Artesian 230kV Substation Expansion Project CPUC Minor Project Refinement Form

Report No.: MPR-6

Artesian 230kV Substation Expansion Project (D.19-07-007)

Minor Project Refinement (MPR) 06: Site Photographs

Photo 2. Overview of proposed crane work area vs. original work area. End of maintained access road indicated by red dashed line. Outrigger placement will be within natural openings in vegetation under the guidance of a biological monitor. View south on October 8, 2020.

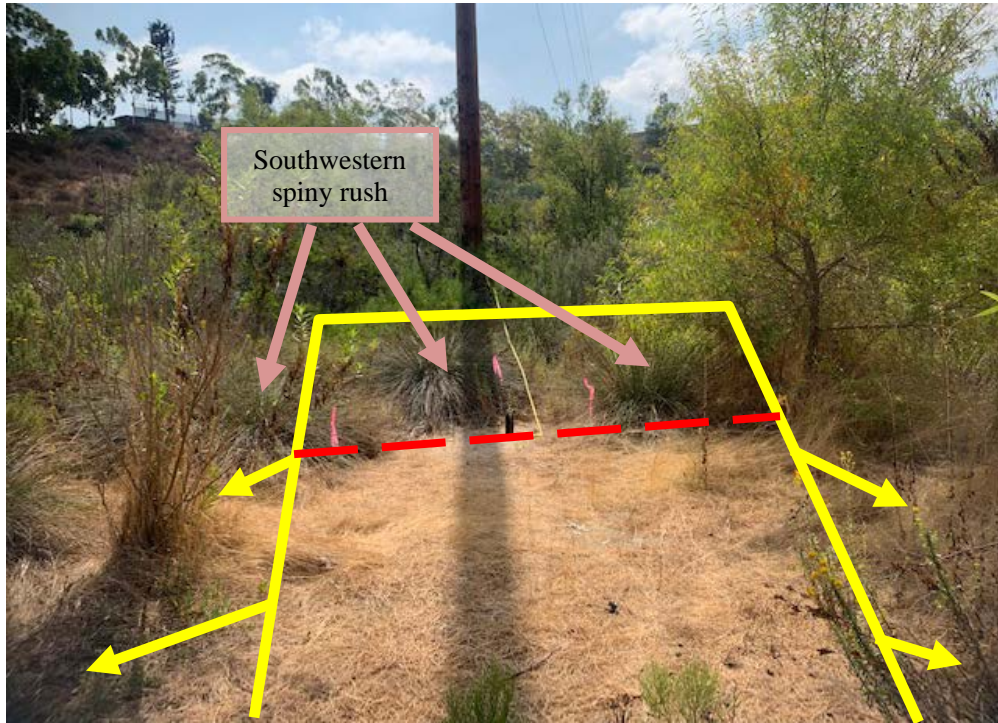
The requested change is to make minor revisions, directly adjacent to the work area, to allow for overland travel and outrigger placement to stage a crane truck instead of a bucket truck near the existing wood pole; a crane truck is needed at this location due to the height and configuration of hardware on the existing wood pole. (See photos of proposed minor revisions in Attachment A).
